M5329EVB

Product Change Notification

1 PCN 320 M5329EVB Baseboard 5V Issue

Figure 1.1: Backside of SDK Baseboard

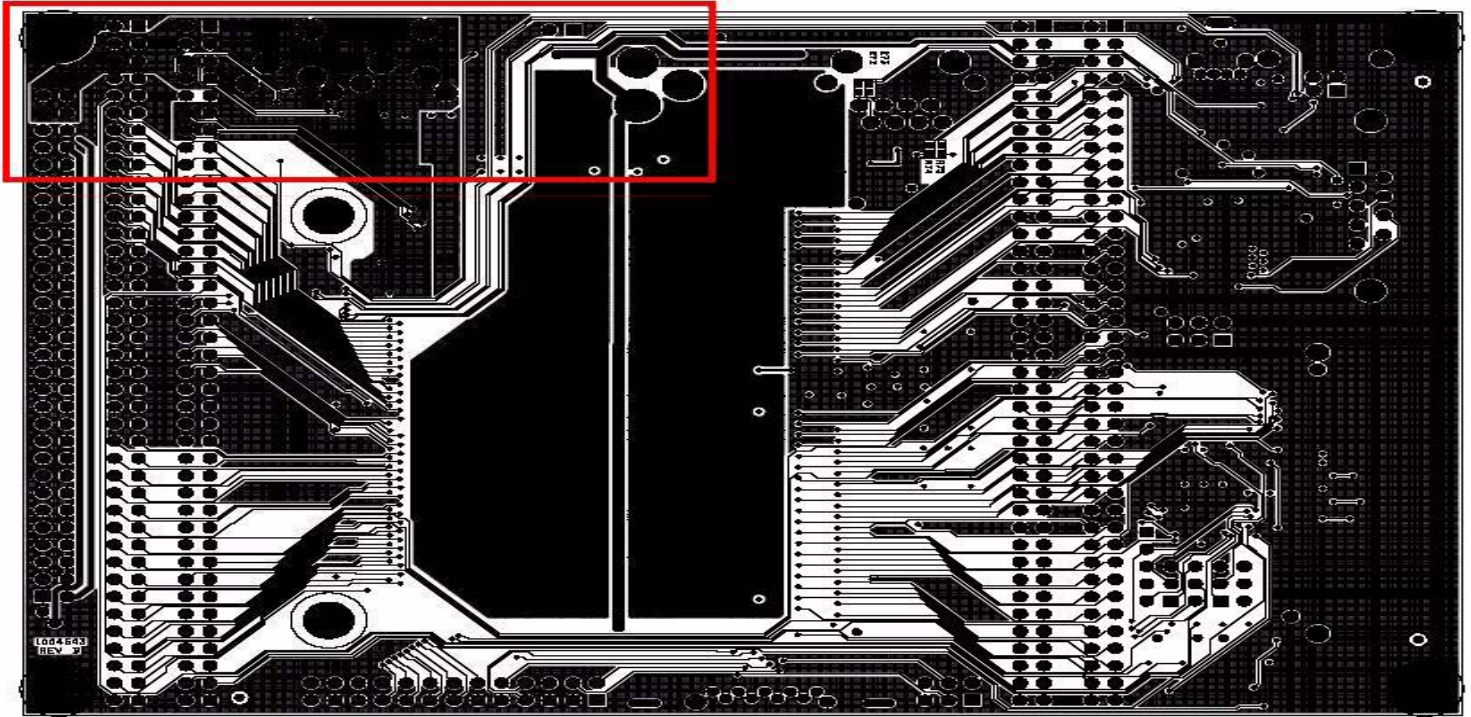
Due to a manufacturing issue with the printed circuit board (PCB), the 5V signal on LCD connector J11 is not present on pin 54 and pin 3.

On the backside of the SDK PCB, solder a wire connecting J12 pin 1 to J11 Pin 54.

Figure 1.1 shows the backside of the PCB. The area outlined in red indicates where the rework will be performed. Figure 1.2 is an enlarged image of the outlined rework area. Two red arrows point to the pin locations that need to be connected by the wire.

Rework instructions are provided in this document for customers who wish to manually correct the issue. The rework instructions involve soldering a wire to the bottom side of the SDK PCB.
